Interactive comment on “Hydraulic modelling of drinking water treatment plant operations” by G. I. M. Worm et al.

Received and published: 16 December 2008

We would like to thank the referee for his or her comments. The referees questions (Q) have been replied to with answers (A).

Fig. 2.

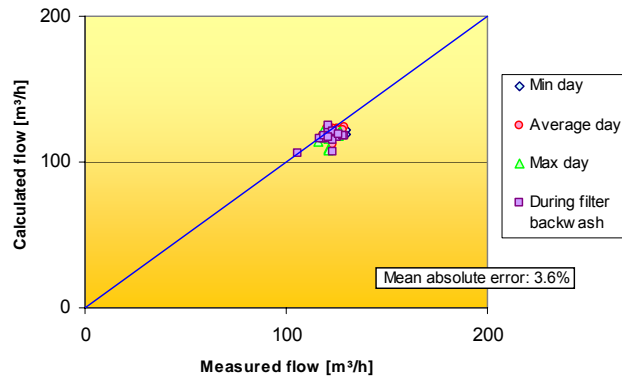
Q: The graph of validation accuracy reports a commendably low MAE of 3.6%; but by eye data match is poor.

A: The poor eye data match in comparison to the other results are caused, most prob-

ably, to the different scales used. The scales have been equalled, yielding updated Fig 2, 4 and 5.

Fig. 5.

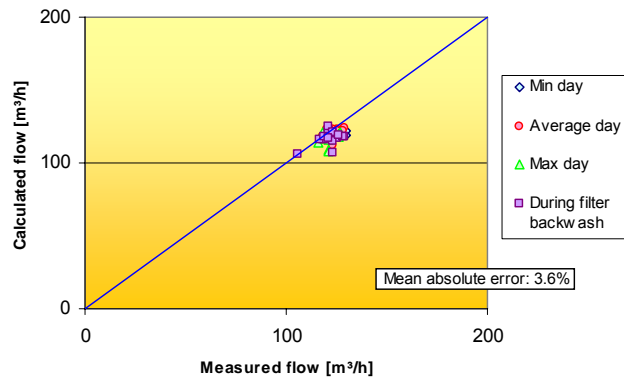
Q: The other processes look to be a better fit, but with the sand filters having the calculated flow consistently greater than the measured flow.

A: The referee mentions the sand filters have the calculated flow consistently greater than the measured flow. This was further analysed by the authors. Obviously the pumps deliver more water than would be expected. Authors consider it's likely the formula used to calculate the pump speed (technical specification current frequency controller) is not accurate. For the percentage of the speed control 0% equals an electricity frequency of 13 Hz in stead of 15 Hz and 100% equals an electricity frequency of 56 in stead of 58 Hz. As can be seen in Figure 5 model results are more balanced and have a higher accuracy as well.
